The following changes to the tender documents are effective immediately and will form part of the contract documents:

RCMP HIGH LEVEL DETACHMENT BUILDING

**SKM-1**

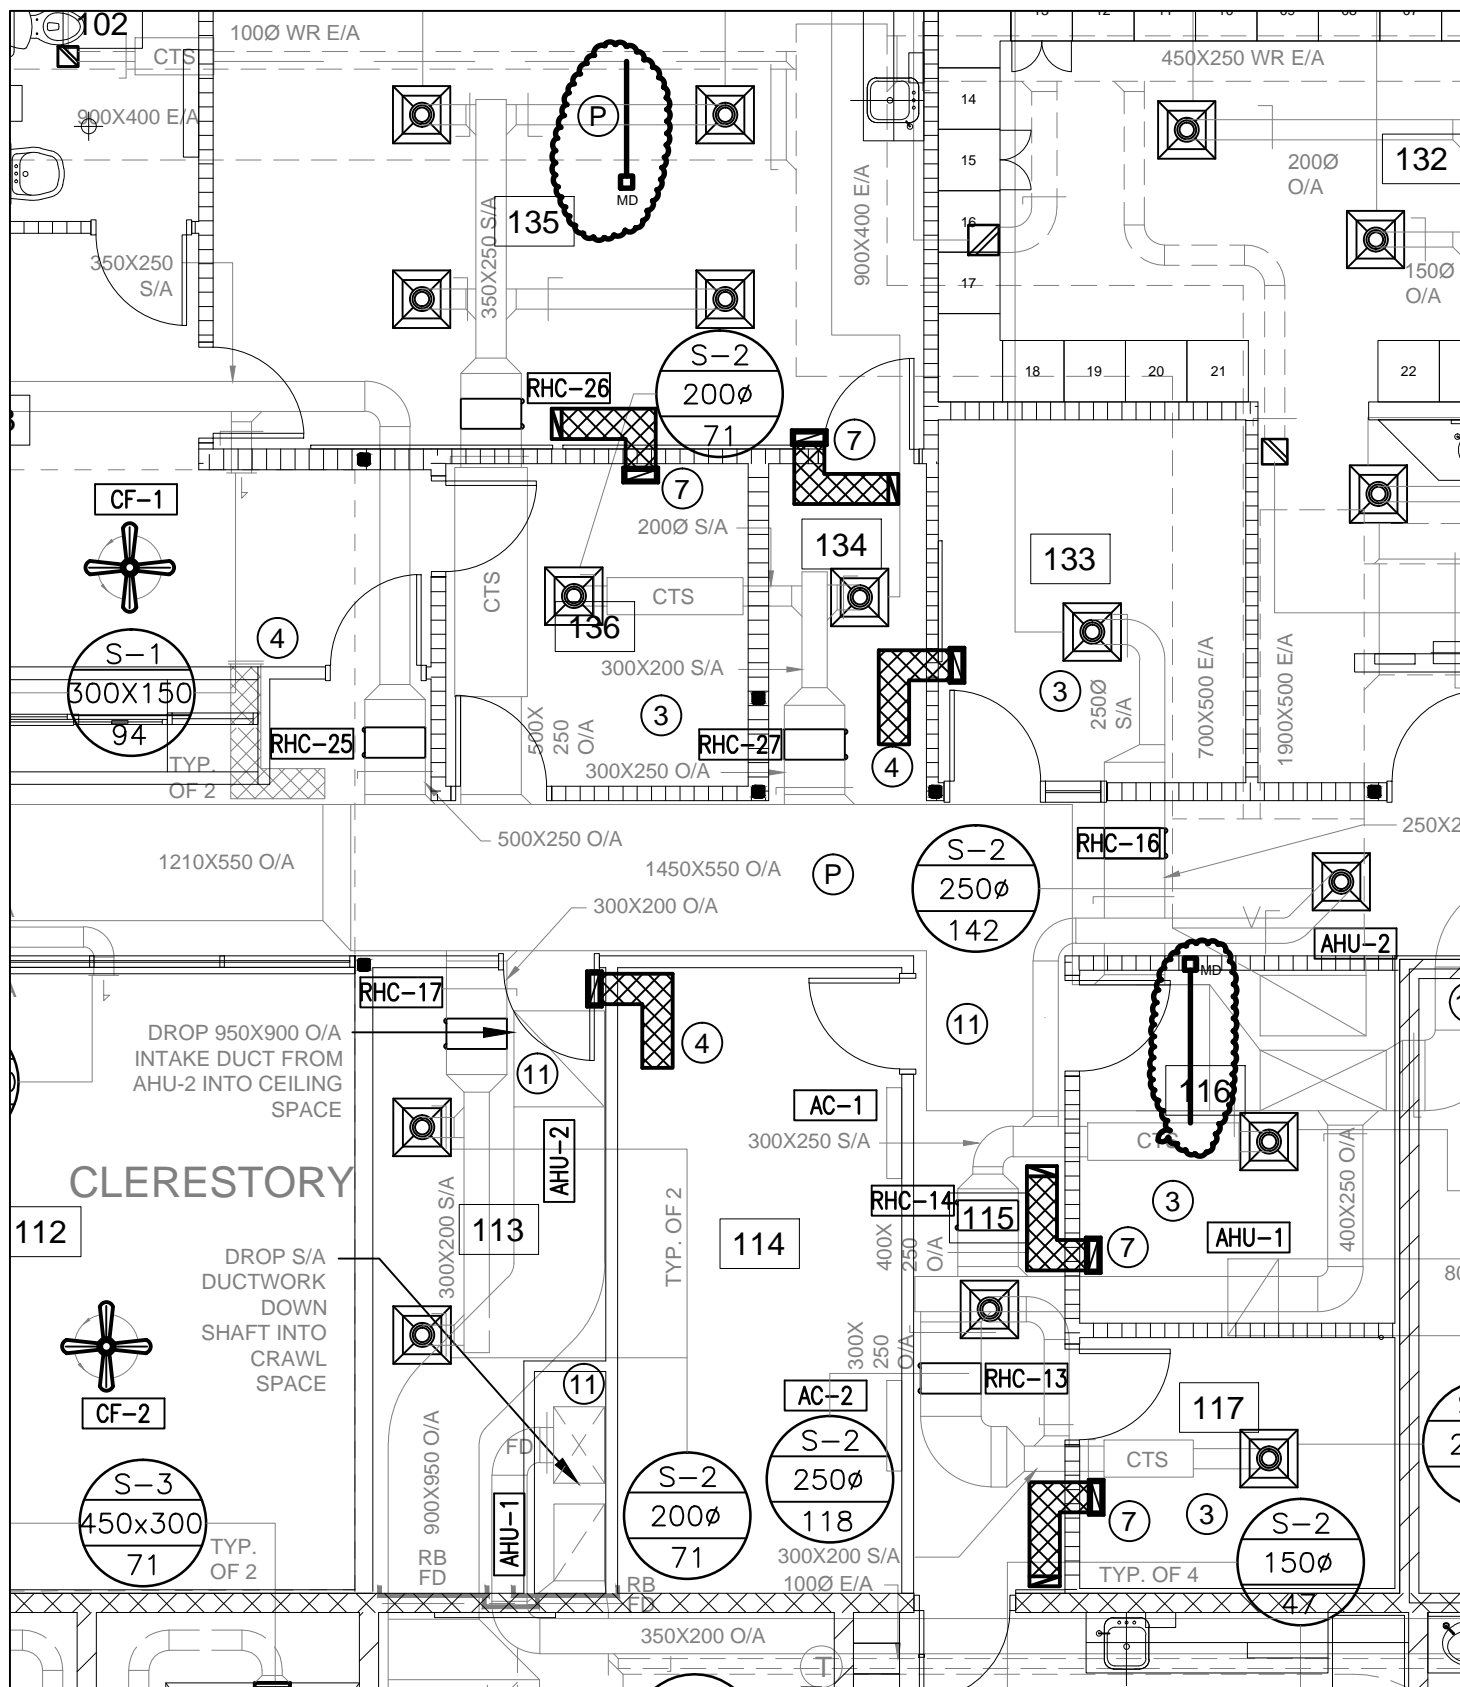
- .1 Note 5: provide fire dampers on all ducts passing into / through rooms: 111, and 124. Refer to attached sketches SKM-1,2 & 3.
- .2 Provide motorized dampers and static pressure sensors on 1450 x 550 S/A and 900 X400 E/A ducts serving administration area interlock with AHU-2. During occupied time MDs to be in open position. During un-occupied time dampers to be in closed position. Refer to attached sketch SKM-1.
- .3 Re-route S/A duct serving 109 as per attached sketch SKM-1.
